SerComm Corporation 中磊電子股份有限公司

Date: August 11, 2011

It is acknowledged by SerComm Corporation. that the modification list below will be installed to our Model: OC810 in order to comply with FCC Approval requirements. These modifications will be incorporated into each unit sold and mass production under the rules.

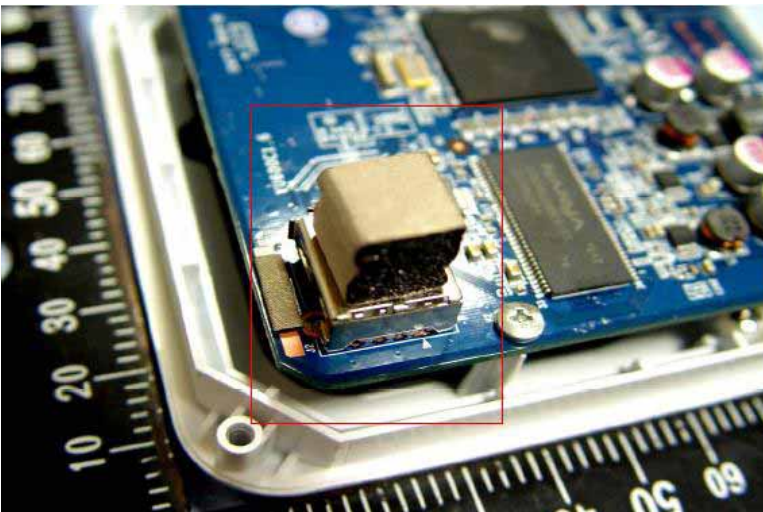
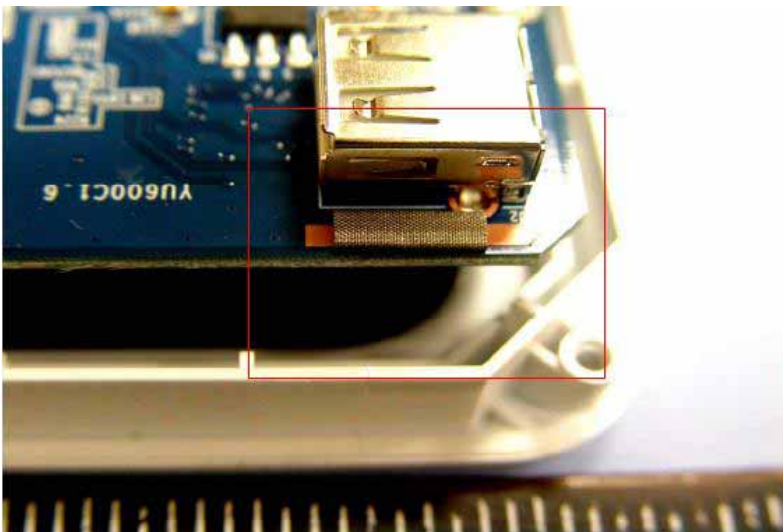
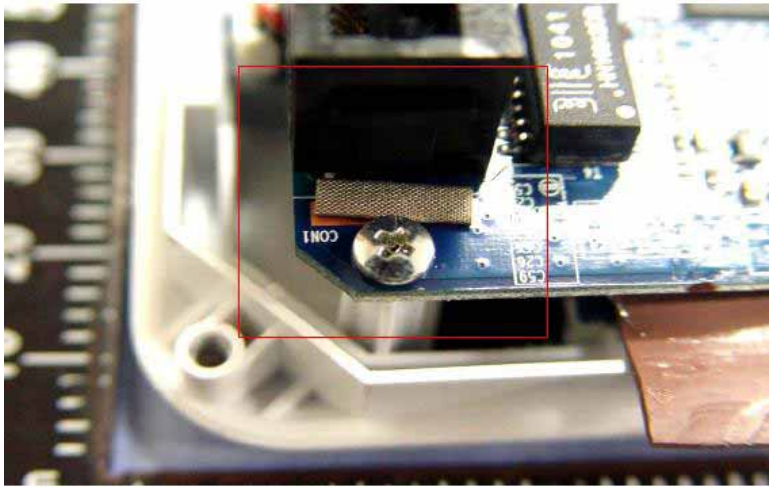
Added copper foil Gasket on the PC board & USB , please refer to EUT photos.
